Newcastle Port Corporation

Capital Strategic Dredging Project, South Arm, Hunter River

Submissions Report

September 2013

Figure 4-2 Saltmarsh

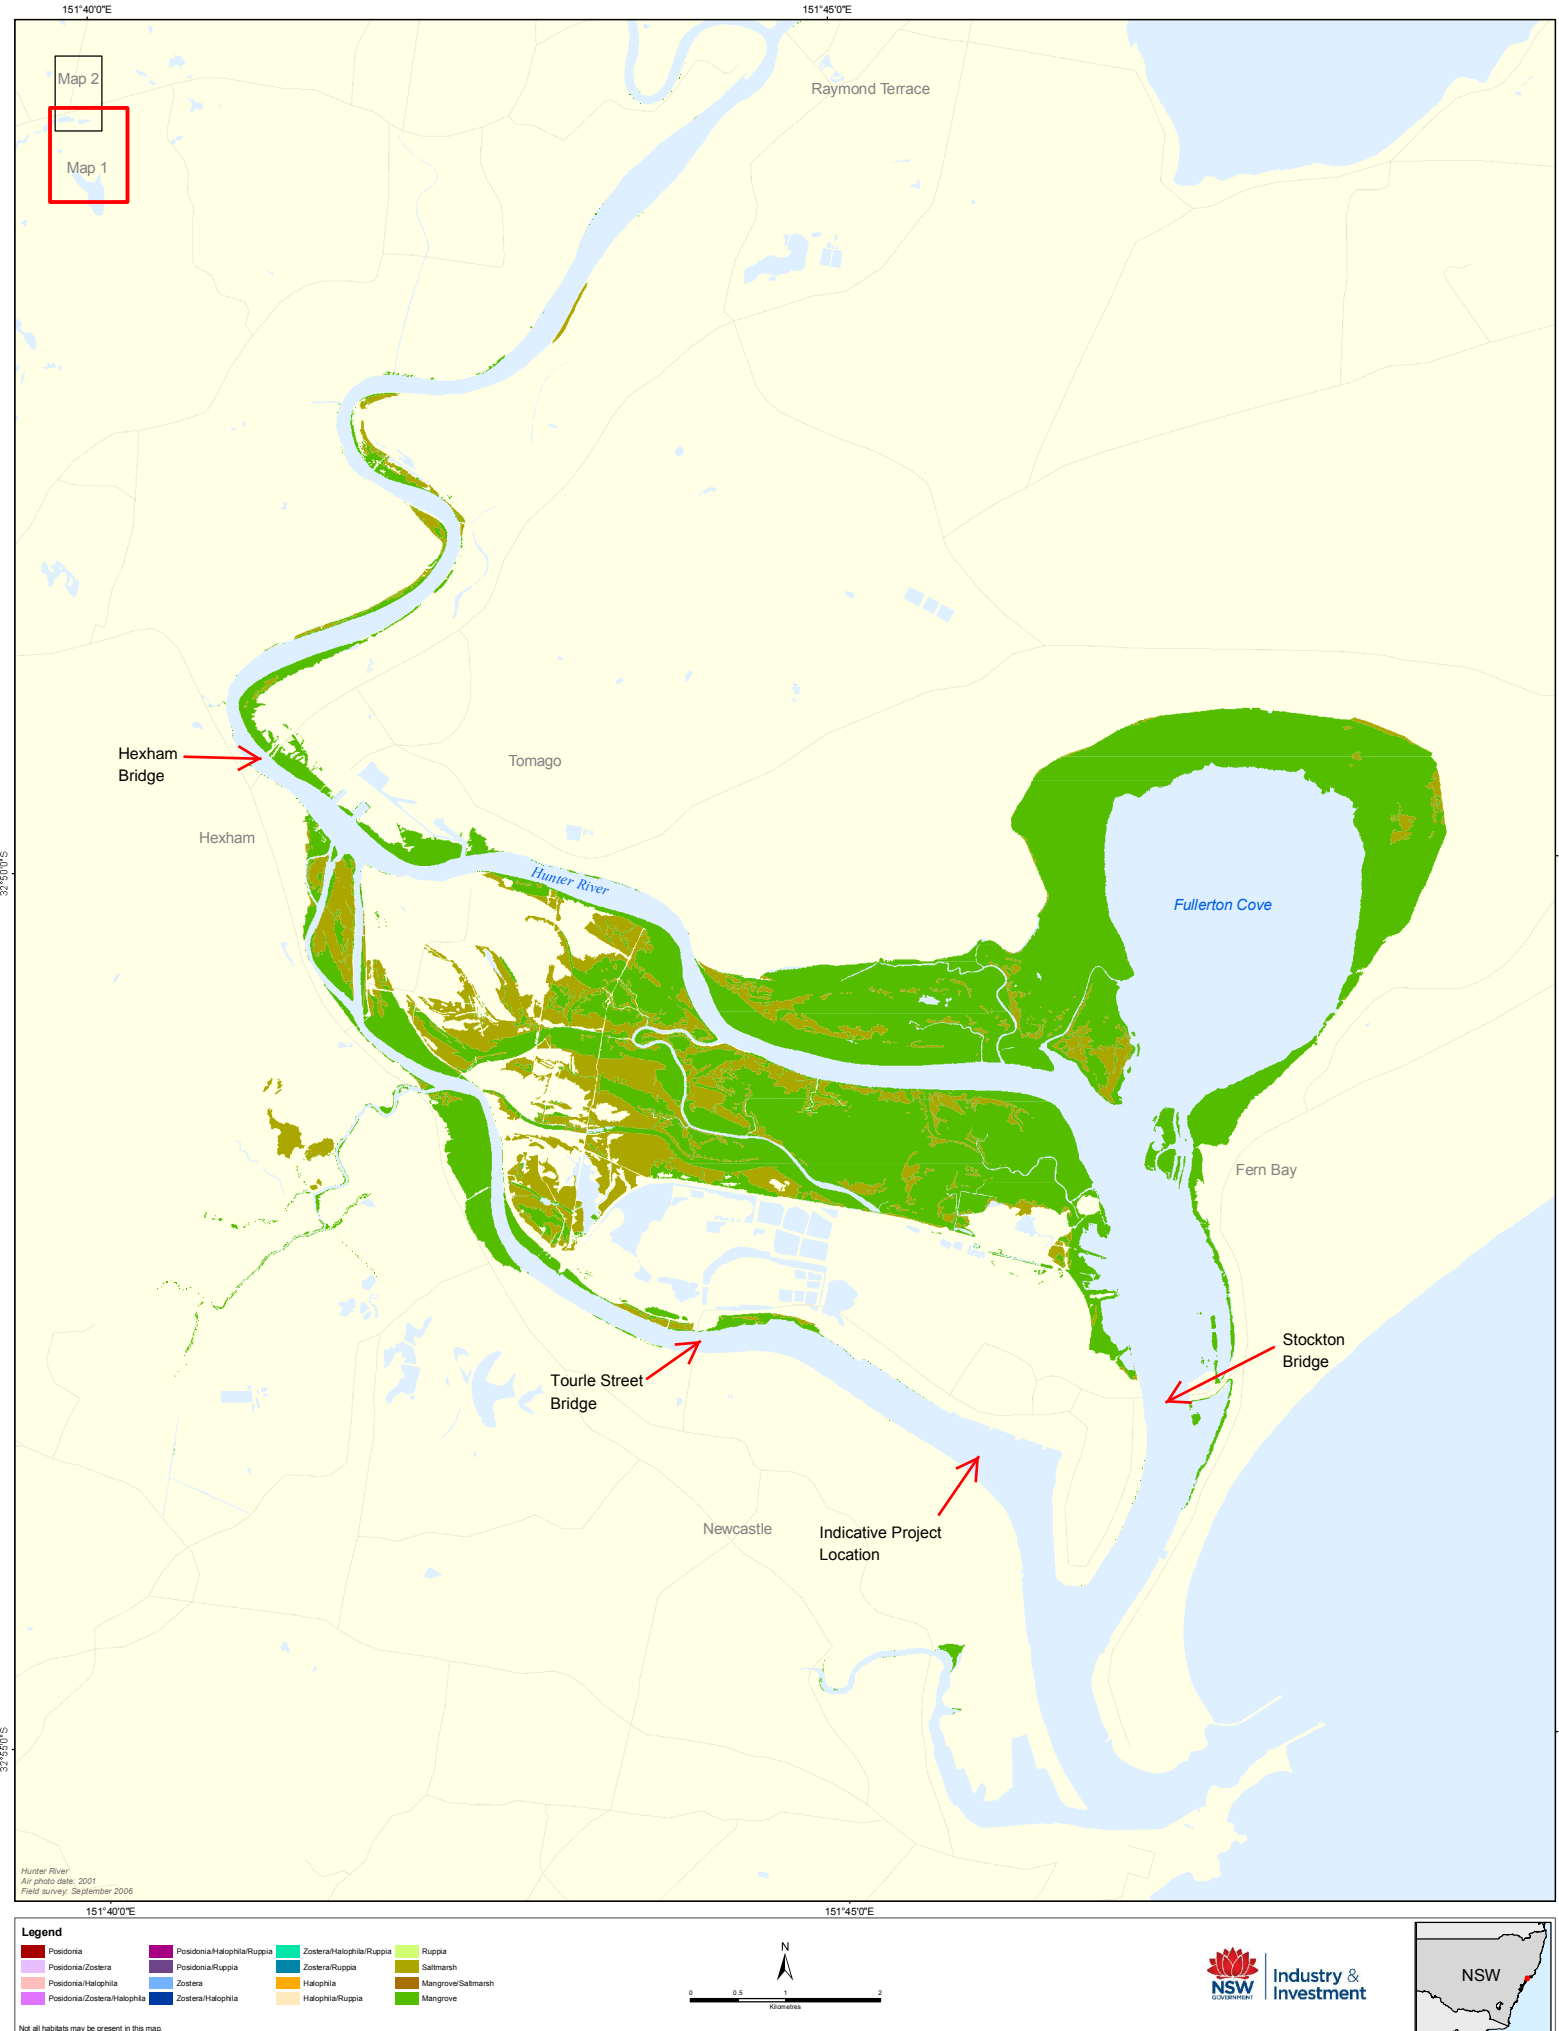
NPC does not dispute that there may have been a loss of Coastal Saltmarsh areas and an increase in tidal depths in the Hunter River over time. However, it is noted that since the arrival of Europeans in the Newcastle and Hunter Valley area the entire Hunter River catchment has been subject to substantial modification including broad scale land clearing and other land uses (resulting in increased sedimentation), tributary creek damming and diversions, land reclamation, water extraction, breakwater construction, foreshore improvement works, navigational dredging, flood levees and flood drainage relief channels. Natural events, in particular flooding, will have also impacted the characteristics of the Hunter River through river bank erosion and sediment depositional processes.
